DSP-20005

Washington Pentecostal Assembly

STAFF REPORT

SUBJECT: Detailed Site Plan DSP-20005
Washington Pentecostal Assembly

SOUTH AND NORTH VIEW ELEVATIONS

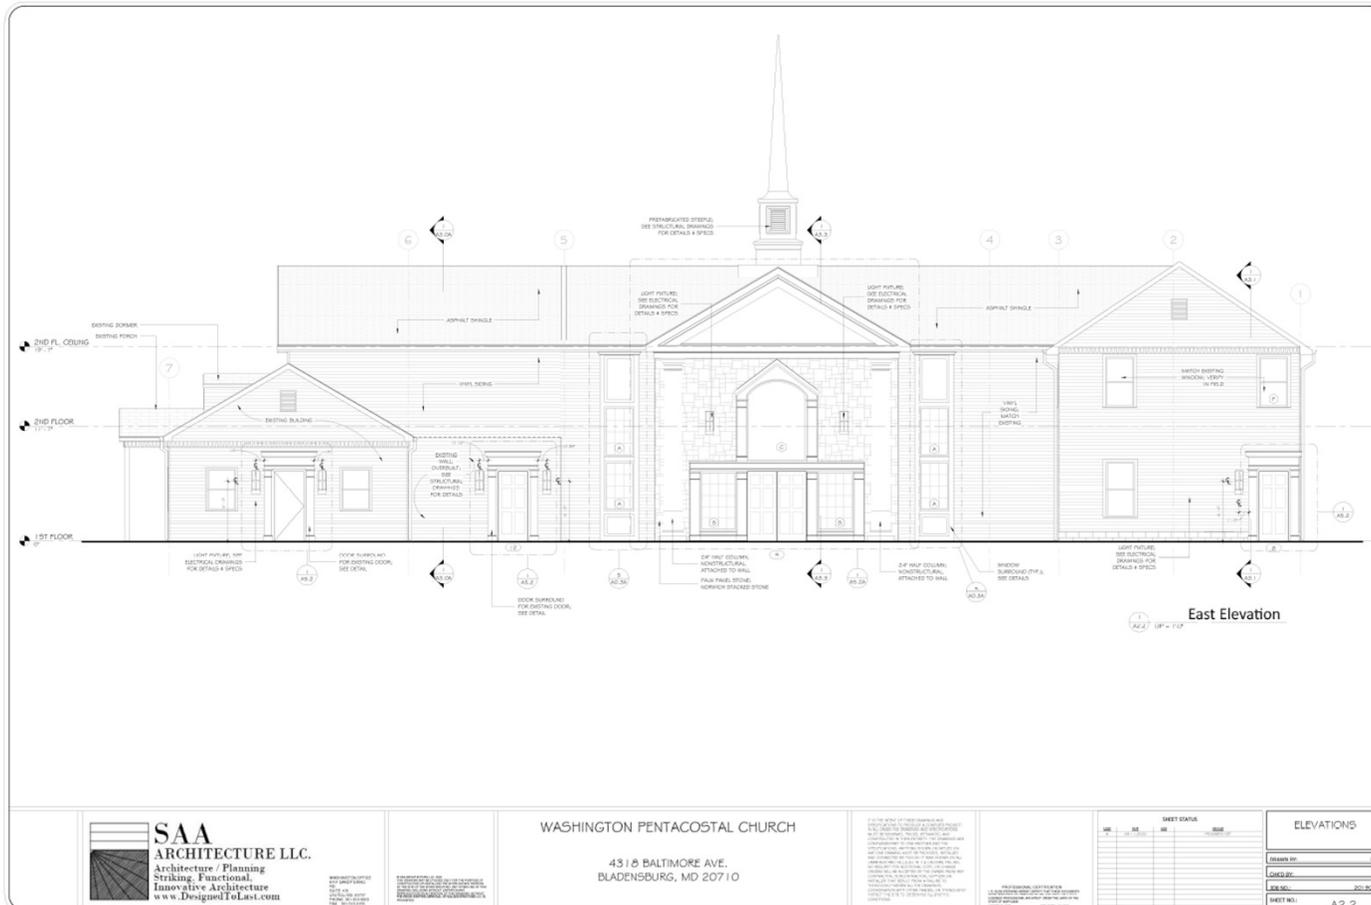
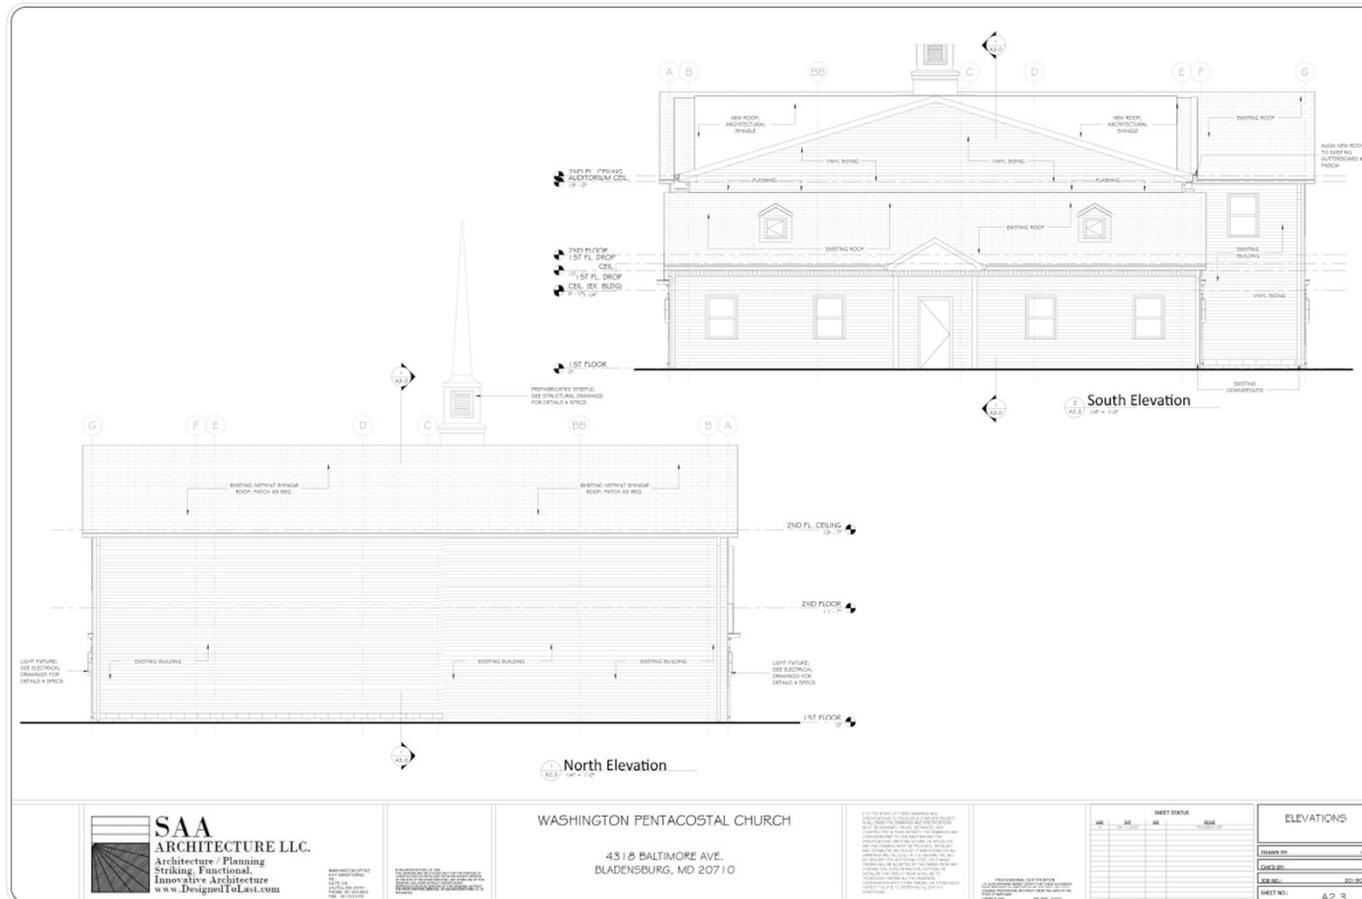
- b. **General Building Envelope Standards for Elements – Fenestration (page 176):** Per the General Building Envelope Standards for Elements section of the sector plan, ground-level façade fenestration shall comprise between 40 and 90 percent of the façade and the upper-story shall be between 20 and 60 percent. Given the fact that the proposal is improving the existing building fenestration within the range not to impede the structural integrity, staff can generally support the modification. However, the applicant should provide further improved fenestration, to the extent possible, with exhibits showing the percentage of the opening, and reviewed by urban design staff for certification. Therefore, the condition is included herein.

- d. **Storefront Building Envelope Standards for Elements – Fenestration (page 180):** Similar to the modification requested for the General Building Envelope Standards for Elements – Fenestration, the applicant is requesting to modify the façade fenestration requirement. Per the Storefront Building Envelope Standards for Elements section of the sector plan, ground-level façade fenestration must be between 40 and 90 percent of the façade. The existing building does not meet this requirement, and even with the proposed stone vestibule with glass and large doors, the building will not meet the fenestration requirement. Similar rationales apply from the General Building Envelope Standards for Elements to this modification.

- (1) Detail sheet for items such as the prefabricated steeple and building materials.
 - (2) Improve fenestration (larger or additional windows and doors allowing light and views) for building elevations and obtain approval from Urban Design staff. Diagrams showing the percentage of openings should be provided as well.
